CITY OF ALBUQUERQUE

RE: **Mercado el Milagro**
10000 Central SW
Conceptual Grading Plan Stamp Date: 5/20/19
Hydrology File: L09D042

Based on the submittal received on 5/20/19 the above-referenced submittal cannot be approved for Site Plan for Building Permit until the following are corrected:

SHEET NO:
CG-101

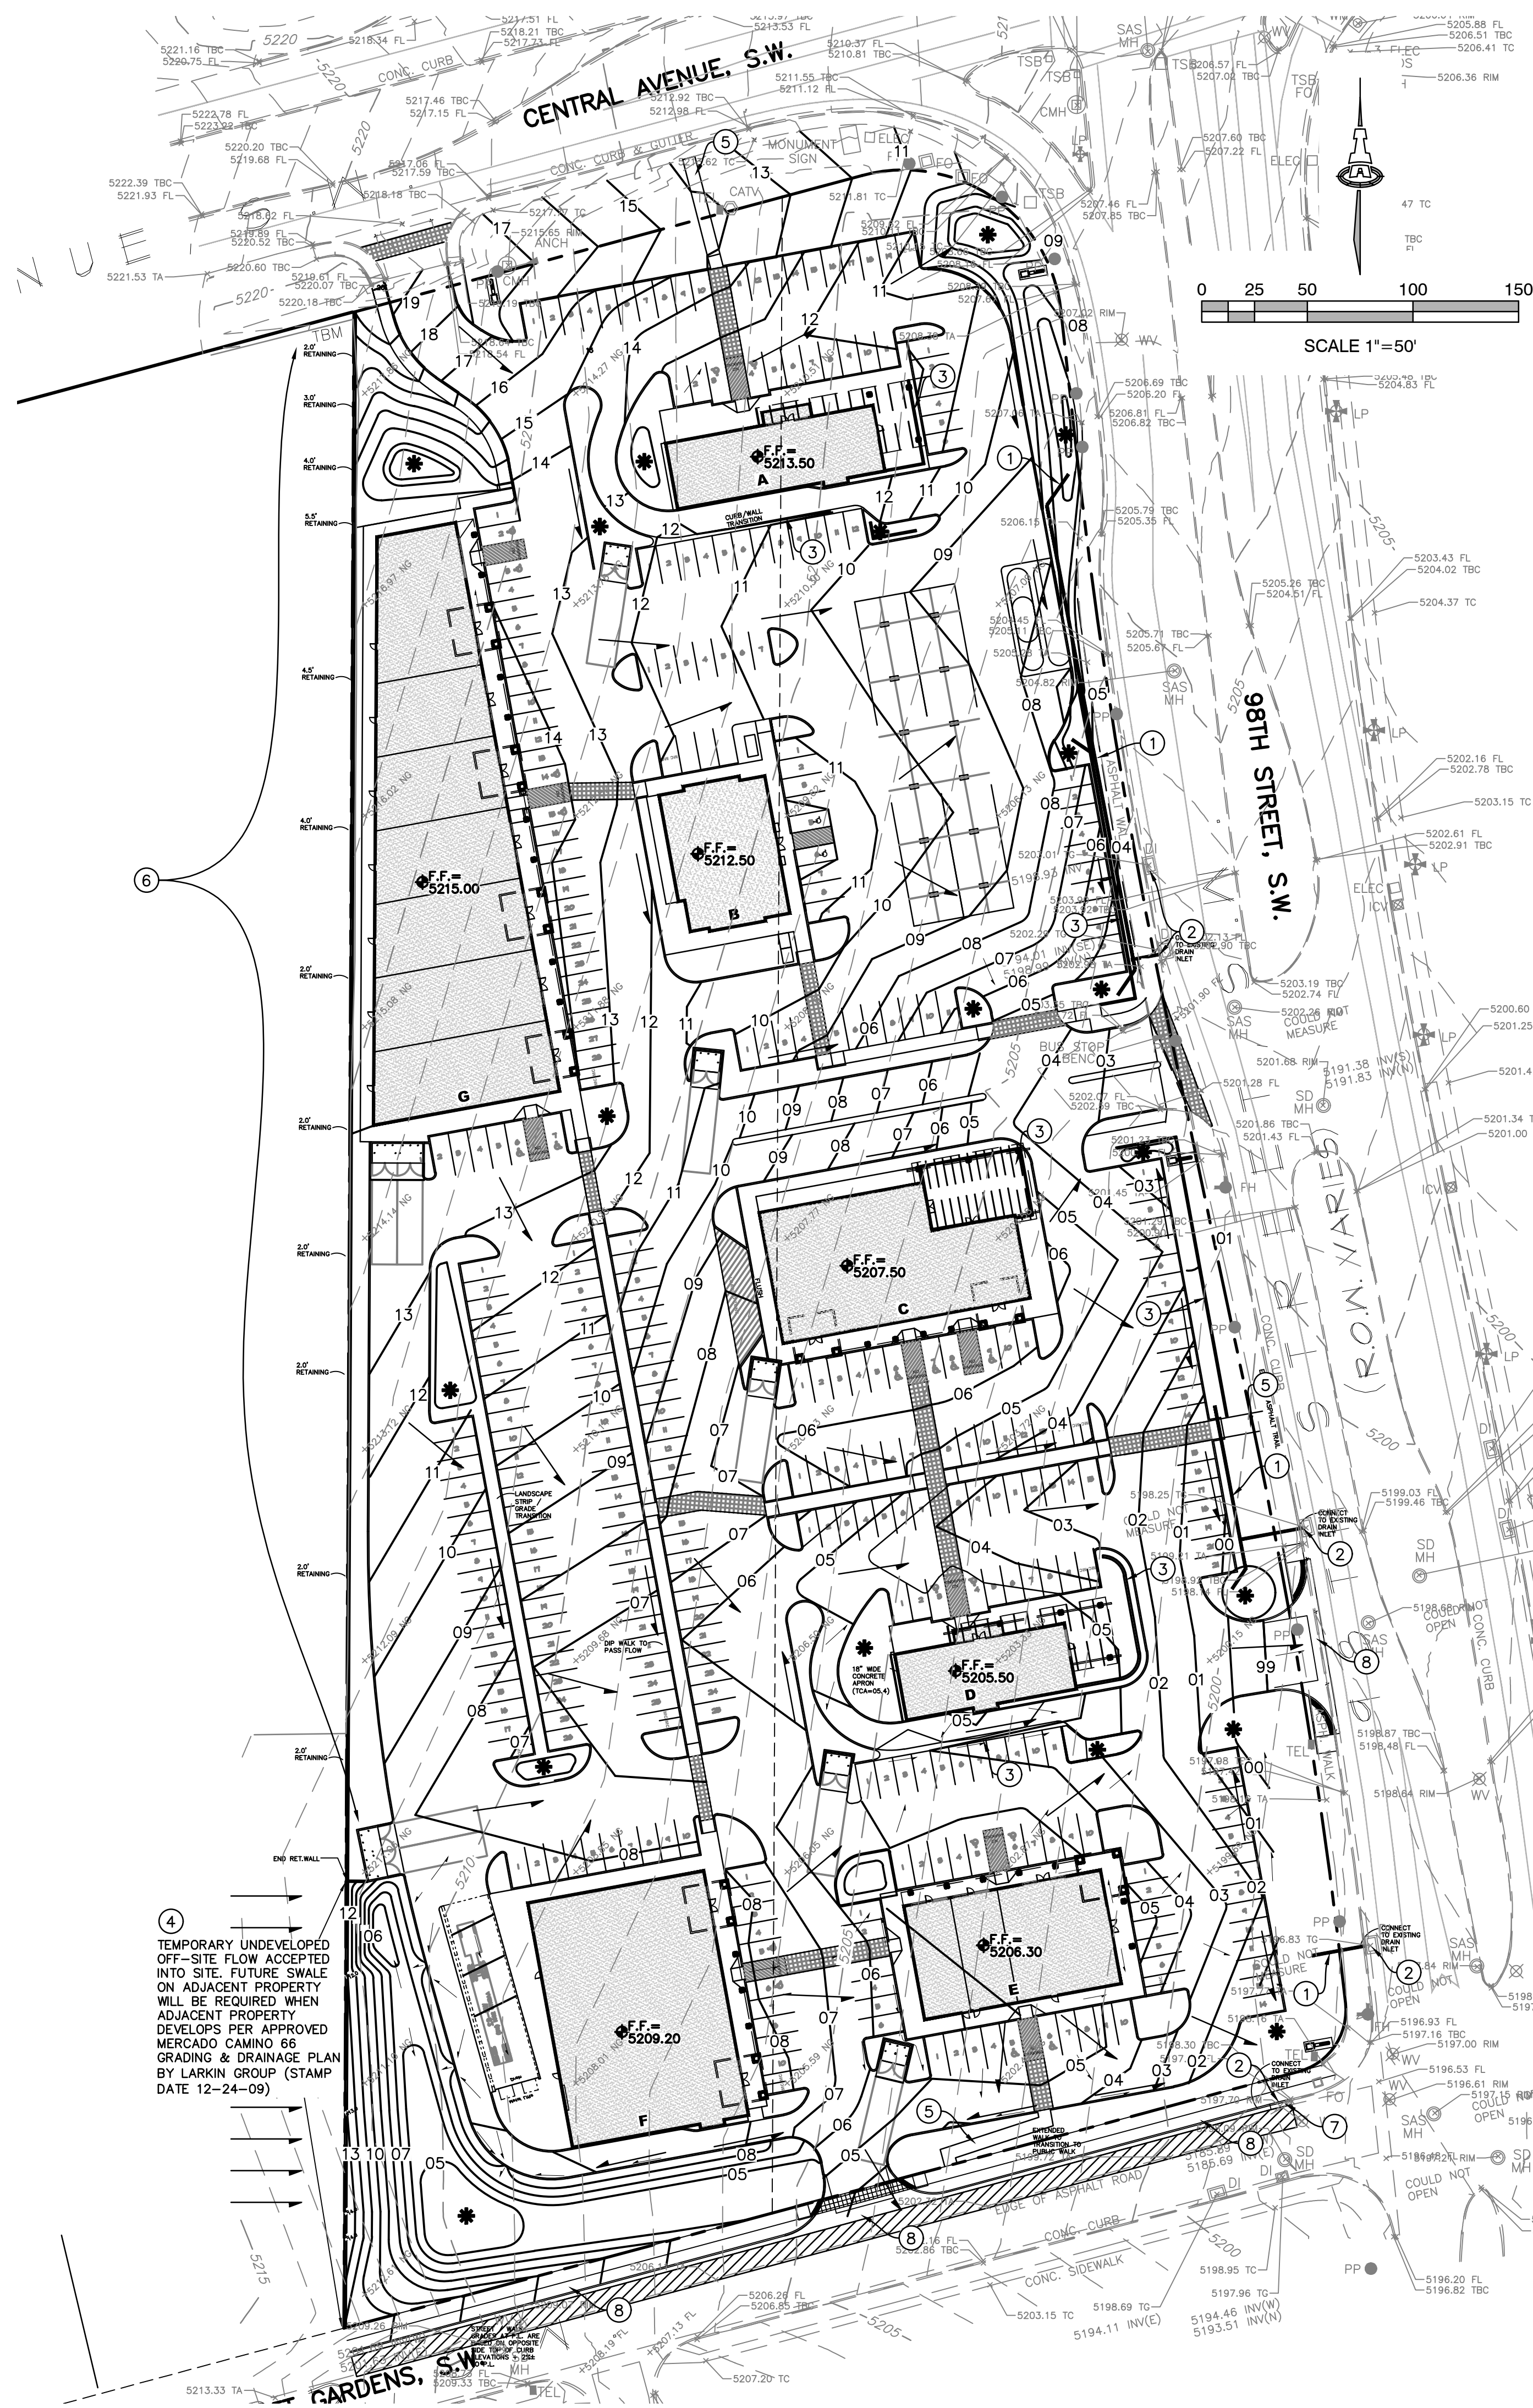
1. This project will require a short Drainage Report to address the design and construction of the 42" storm drain that is required along Sunset Garden.

- a. The SAD 222 Drainage Report stubbed the 42" storm drain in anticipation of it eventually receiving 88cfs from developed basin A1-D. Developed Basin A1-D anticipates 109cfs; the remaining 21cfs routes into the 98th St storm drain.

- b. The 2013 Amole-Hubbell Drainage Report anticipates 164cfs from this basin, but that includes the mobile home park on 102nd St, which self-ponds; the Sunset Garden storm drain needs to be designed to intercept 88cfs.

- c. Some inlets (1x double-A and 1x single-C) were built on the south side of Sunset Garden with the Sunrise Rach Subdivision, but the supporting design and calculations are missing.

- d. Street capacity and inlet calculations need to be prepared for the existing and proposed inlets in Sunset Garden.
 - e. Storm drain profiles, calculating the HGL from the energy grade line, need to be prepared. Use the HGL and velocity in the 98th St storm drain as the control surface.

- f. Allowable discharge to each inlet along 98th St needs to be established. i.e. what is the allowable flow into the back of each inlet from Mercado el Milagro? Ensure the flow in the 98th St storm drain does not exceed 21cfs including the flow generated by the road.

- g. Allowable discharge rates to Sunset Garden also need to be established (cfs/ac), using 88cfs as max allowable. Be sure to exclude the area of Sunset Garden Road, which free discharges, when making this determination.

3. Also be sure to include 3x “Connection to Existing Public Inlet” along 98th St on the Infrastructure List.
 4. Provide sections through the pond and retaining walls at west property line, showing proposed retaining walls, garden walls, property lines, existing and proposed grades. In accordance with DPM Ch.22, section 5 part B, grading and wall construction near the property line may not endanger adjacent property or constrain its use.

5. Hydrology recommends offsetting the retaining wall so the footer doesn’t extend under the adjoining property, then providing an armored drainage swale on the uphill side (but still on the Mercado property) to convey flows south to Sunset Garden or the proposed pond.

6. What is the outfall for the proposed pond in the SW corner? Do you need to include sidewalk culverts on the Infrastructure List for this outfall?
